MJ11-A

THE FOLLOWING MODULES/ASSEMBLIES ARE CONTAINED IN THIS DEVICE.  
EACH MAY HAVE ASSOCIATED TECH TIPS, DEC-O-LOG AND FCO's DOCUMENTED  
IN THE MODULE/ASSEMBLY CATEGORY OF THE MICROFICHE LIBRARY

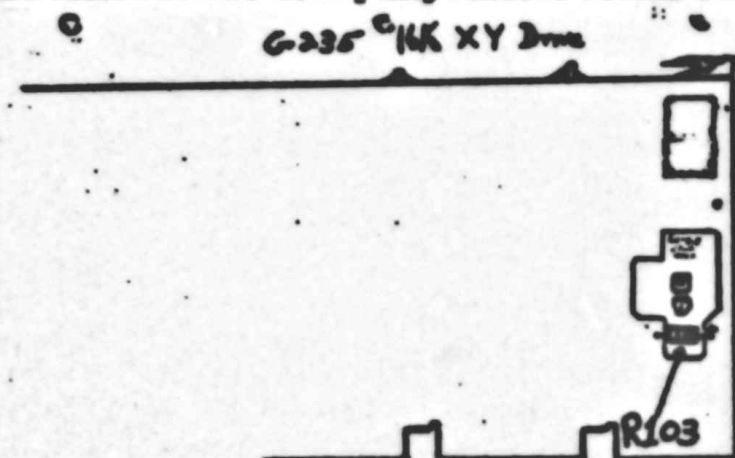
Many reports have been received from the field concerning memories failing high current margins and module set incompatibility (i.e. unable to swap modules). Investigation has shown that the inhibit margins are not properly centered, which could cause marginal operation of the memory under conditions of high drive currents. An ECD (G235-0009) was generated to correct this problem.

Therefore, if a memory exhibits these symptoms, do a visual inspection of the G235 for the ECD. A quick check for the ECD is:

1. Place G235 component side up and fingers toward you.
2. Look at right hand side of module in large etch area (see drawing).
3. If resistor R103 (750  $\Omega$ ) which is across bottom of large etch is not in, ECD has not been installed.

This ECD should be installed before attempting massive module swap or option swap.

ELO # MM 11E-00016

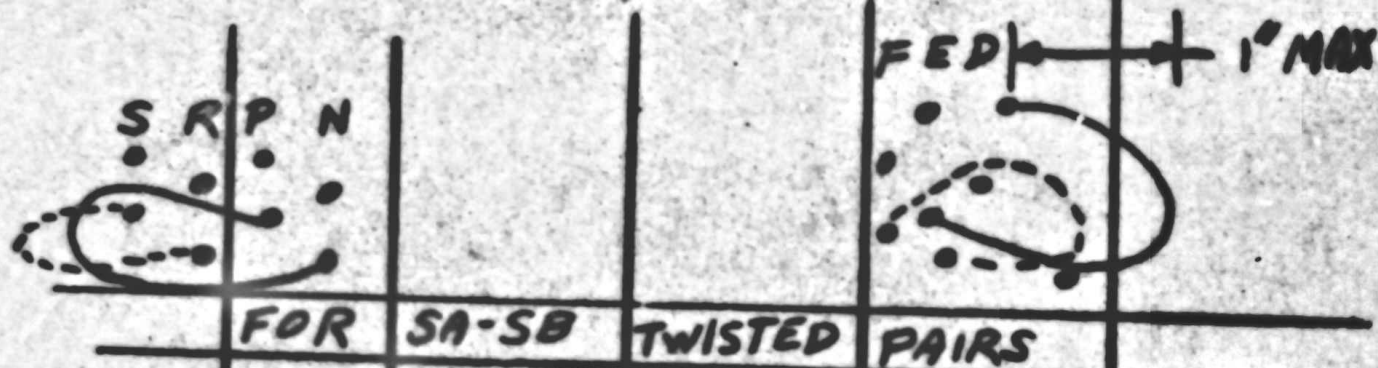
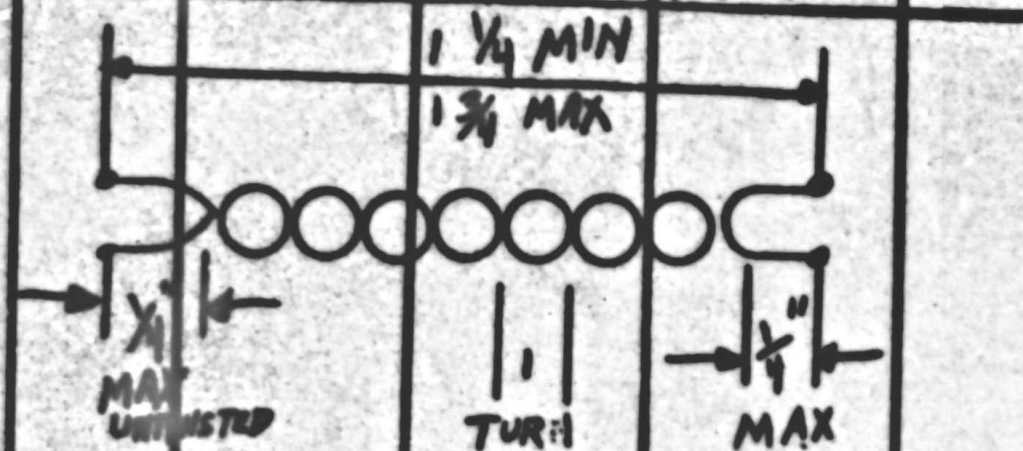
LENGTH SHOULD BE A MAXIMUM OF  
 $2\frac{1}{4}$  INCHES. CHECK DRAWINGS FOR  
 LENGTH AND FOR HOW LOOPS SHOULD  
 BE DRESSED INTO LOGIC.

FOR SA-SB TWISTED PAIRS

TWISTED PAIR TO HAVE 7 TURNS MINIMUM

- SUGGESTED METHOD OF INSTALLATION:
1. PRETWIST THE TWO WIRES.
  2. STRIP TO  $1\frac{1}{2}$  INCHES AND WIRE WRAP LENGTH
  3. STRIP ALL FOUR WIRES TO WITHIN  $\frac{1}{4}$  INCH OF TWIST.
  4. INSTALL WITH WIRE WRAP TOOL.

ECO MM11E-00022  
MMHF REWORK SHEET

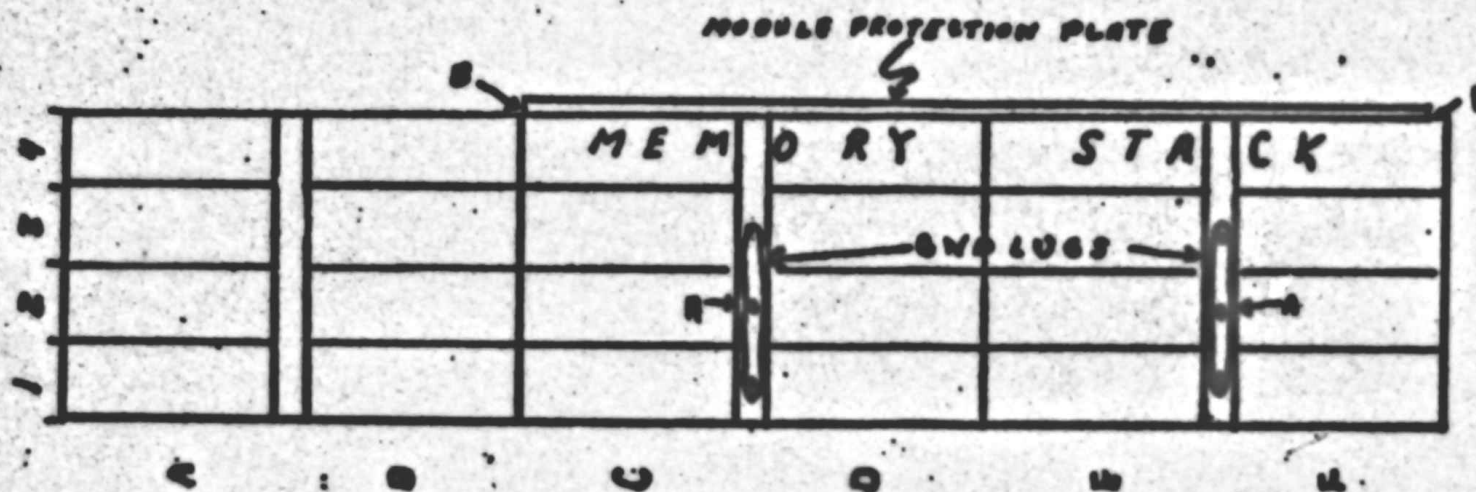
- Carefully install module protection plate per FCO instructions. This requires insertion of the plate under existing wire runs which are easily broken.
- Run maindecs or other programs whose failure indicated the need for this FCO to be implemented. They should now function correctly.

digital	CORP. MEMORY STACK (X DRIVE)		DWS NO. D-05-MM11E-03	REV B
	ENGINEERING CHANGE ORDER	TITLE		
	DATE	BY	DWG. LOC.	
	CHK'D	CHK'D

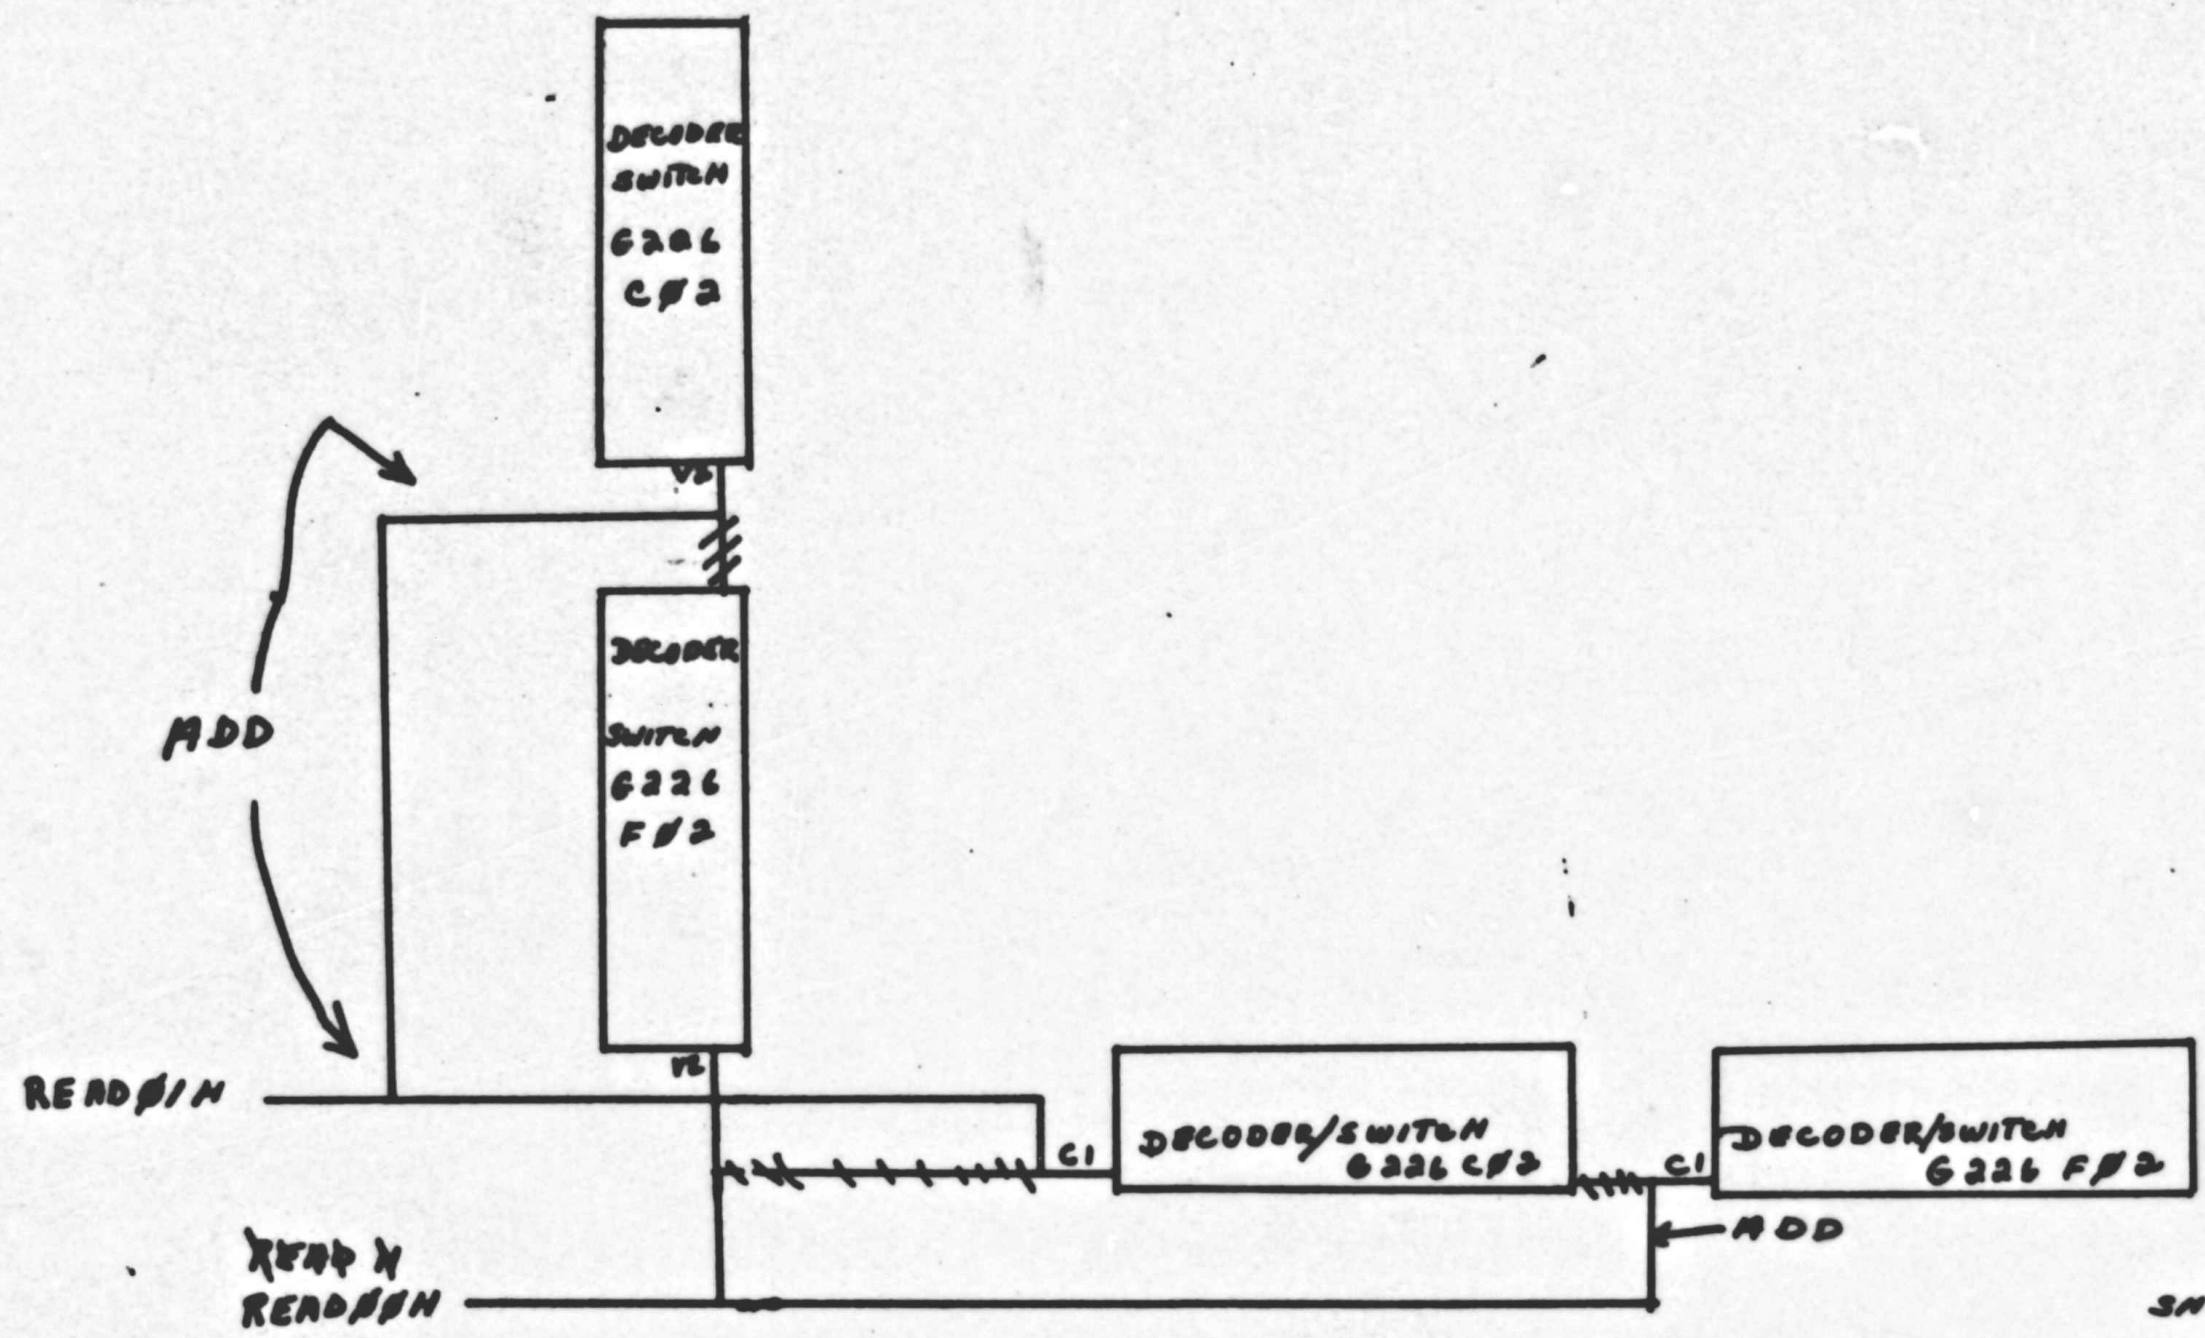
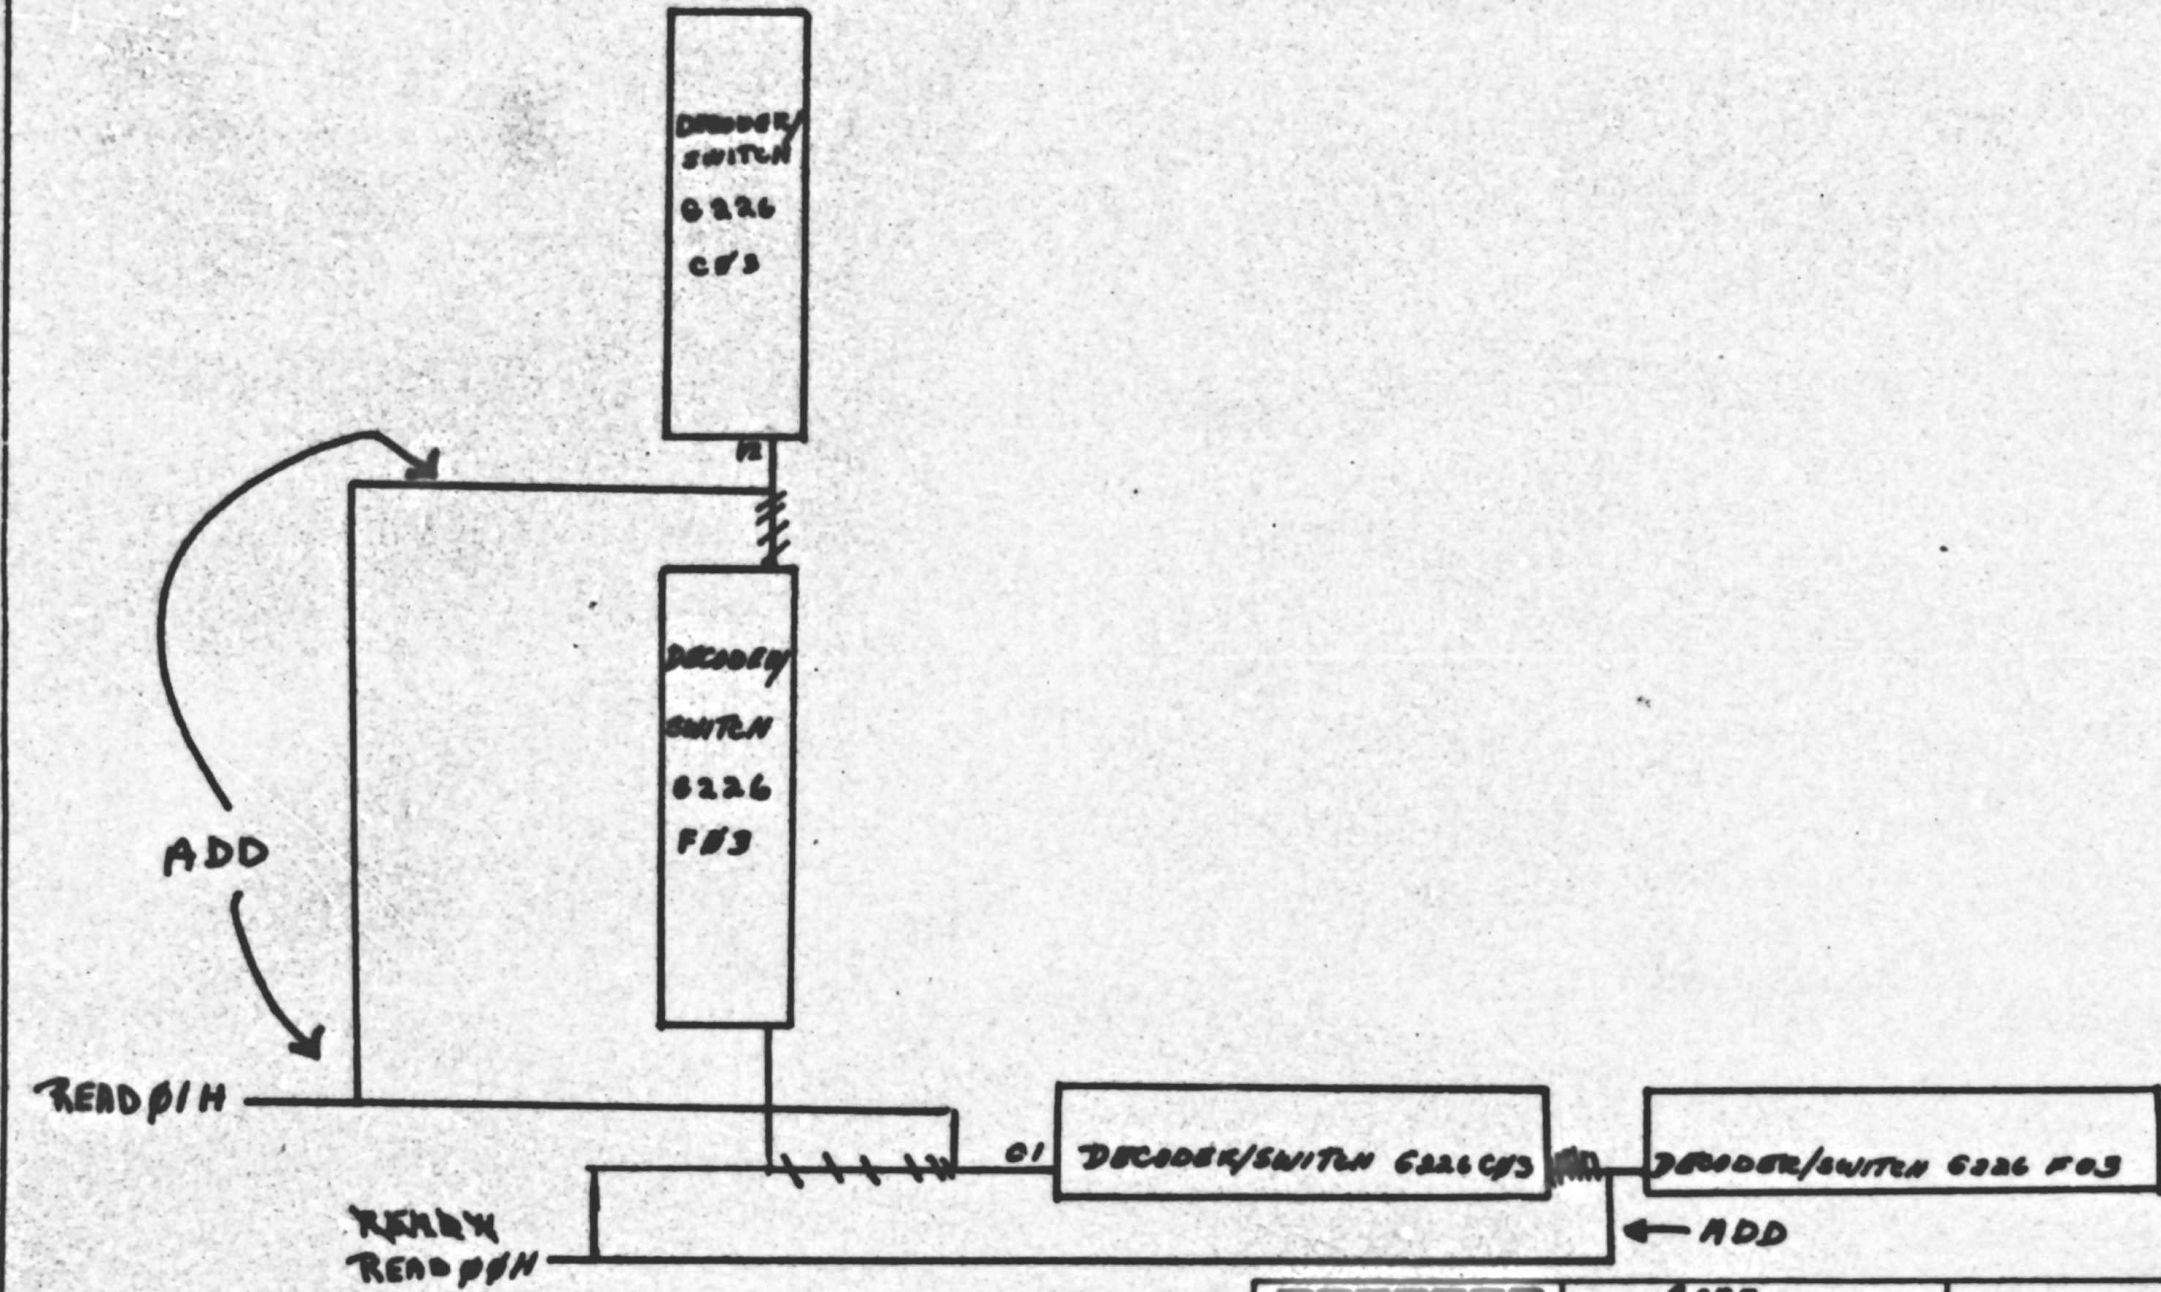
ITEM NO.	DOCUMENT/PART NO.	OLD REV	NEW REV	DESCRIPTION OF CHANGE
1	E-WL-MM11-E-01	D	E 06	Wire List Update
2	D-AD-7006468-0-0	D	E 06	Wire Ass'y MM11-E See final release print.
3	D-BS-MM11-E-03	A	B 06	Core Memory stack (2 sheets) See final release print.
4	A-PL-MM11-E	Z	AA 06	UPDATE PRINT PER THIS ECO.
5	C-DI-MM11-E-01	E	F 06	UPDATE PRINT PER THIS ECO
6	A-PL-7006468-0-0	D	E 06	UPDATE REV PER THIS ECO

ECO MMIF  
MMIF REWORK SHEET

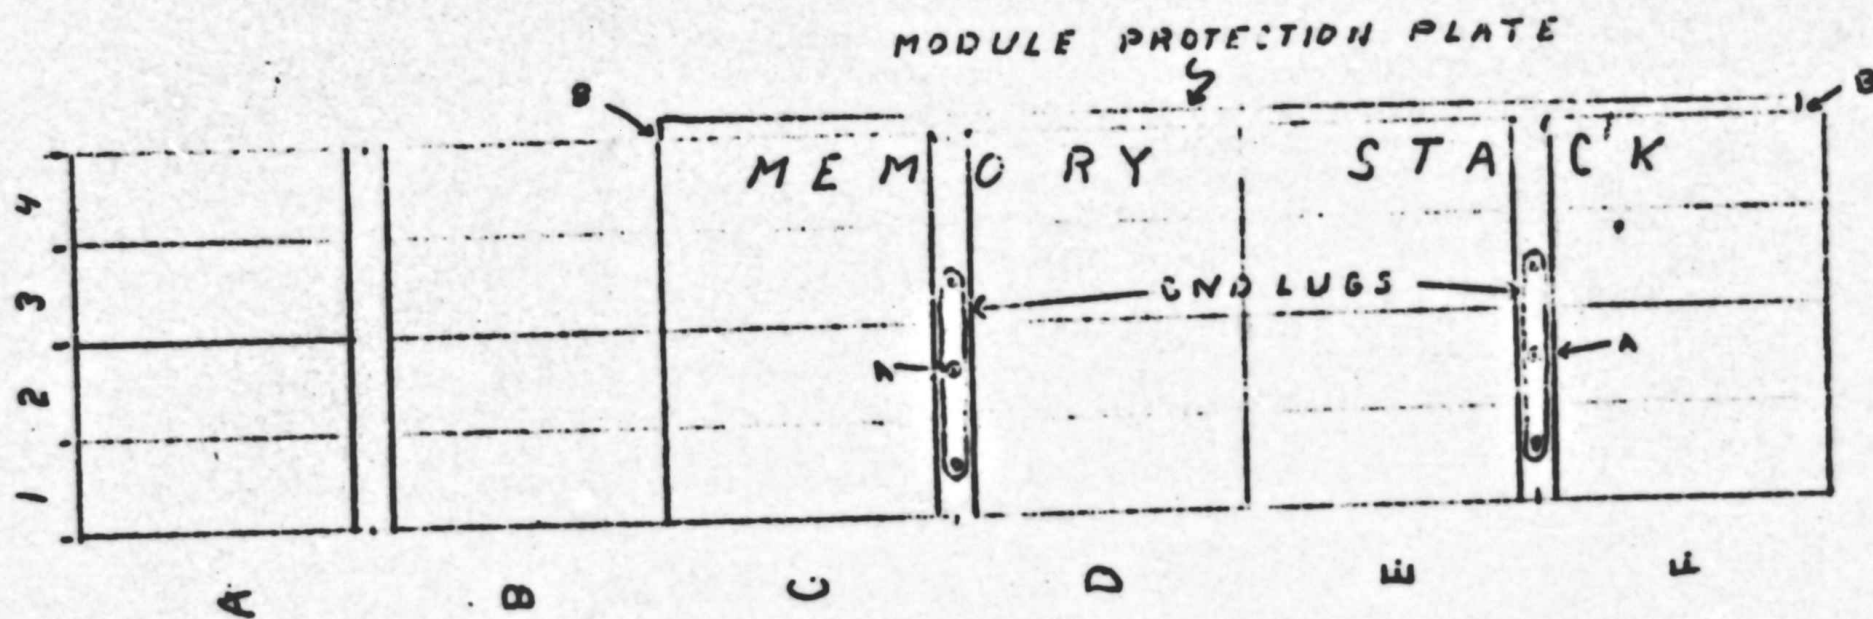
**MM11F-0001 CODE: DF ML: A**  
MAR 72 - PROBLEM: Under some conditions, when other options are placed along side an MM11-F, they fail to operate correctly.  
CORRECTION: Install a module protection plate.  
In-plant effectivity - All MM11-F as required  
Field effectivity - All MM11-F as required  
( Time To Install And Test 1.0 Hours )  
( Kit Contents -PCU/Prints And Parts )

2.	7408490	-	-	07	(Module Protection Plate) Add quantity of 1 to drawing index.	<input type="checkbox"/> DIAGNOSTICS	<input type="checkbox"/> Customer Charge	<input checked="" type="checkbox"/> MECHANICAL	<input checked="" type="checkbox"/> NO

## MM115 REWORK SHEET

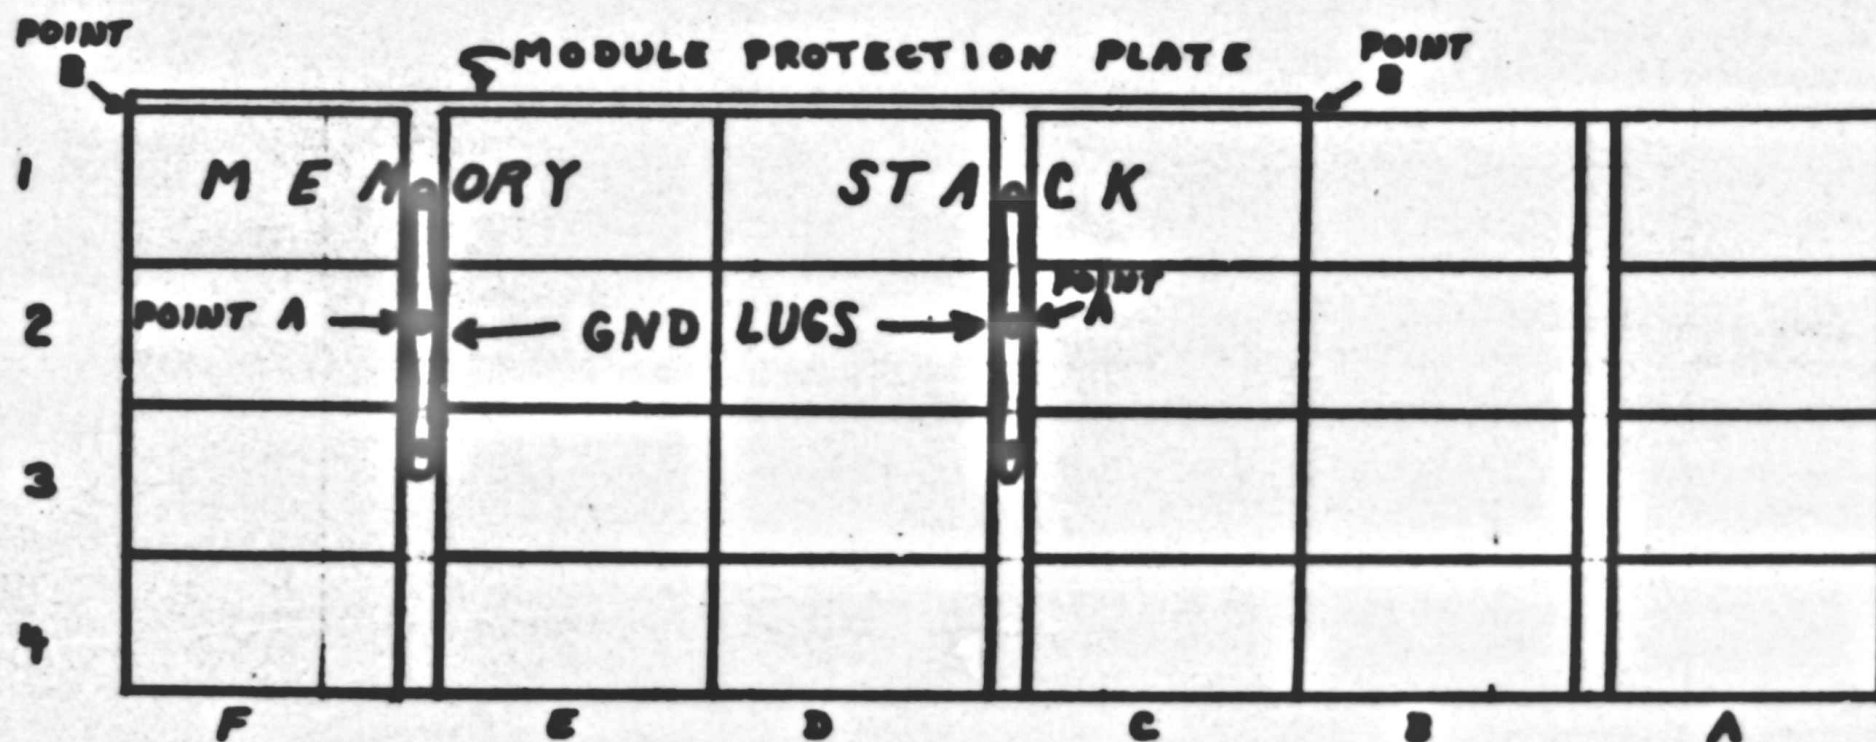
NOTE This FCO is required when other options such as KW11-P, etc. are physically mounted next to an MM11-S memory. Noise generated by the MM11-S may interact with adjacent modules.

ITEM NO.	DOCUMENT/PART NO.	OLD REV	NEW REV	DISP CODE	DESCRIPTION OF CHANGE	DOCUMENTATION AFFECTED	FIELD SERVICE AFFECTED	TYPE OF CHANGE
1.	B-DD-MM1-S	A	B	06	(Drawing Directory) Change per this ECO.  (Module Protection Plate) Add B-MB-7408490-0 to drawing directory.	<input type="checkbox"/> MODEL <input type="checkbox"/> DIAGNOSTICS <input type="checkbox"/> TECH MANUAL <input type="checkbox"/> TESTER <input type="checkbox"/> TEST PROG <input type="checkbox"/> TOOLING <input type="checkbox"/> PEG INST <input type="checkbox"/> ENG SPEC <input type="checkbox"/> PURCH SPEC	<input checked="" type="checkbox"/> YES <input type="checkbox"/> NO <input type="checkbox"/> Customer Champ <input checked="" type="checkbox"/> Product Line Champ	<input type="checkbox"/> ELECTRICAL <input checked="" type="checkbox"/> MECHANICAL <input type="checkbox"/> MODULE ORDER PR MODEL <input type="checkbox"/> YES <input checked="" type="checkbox"/> NO
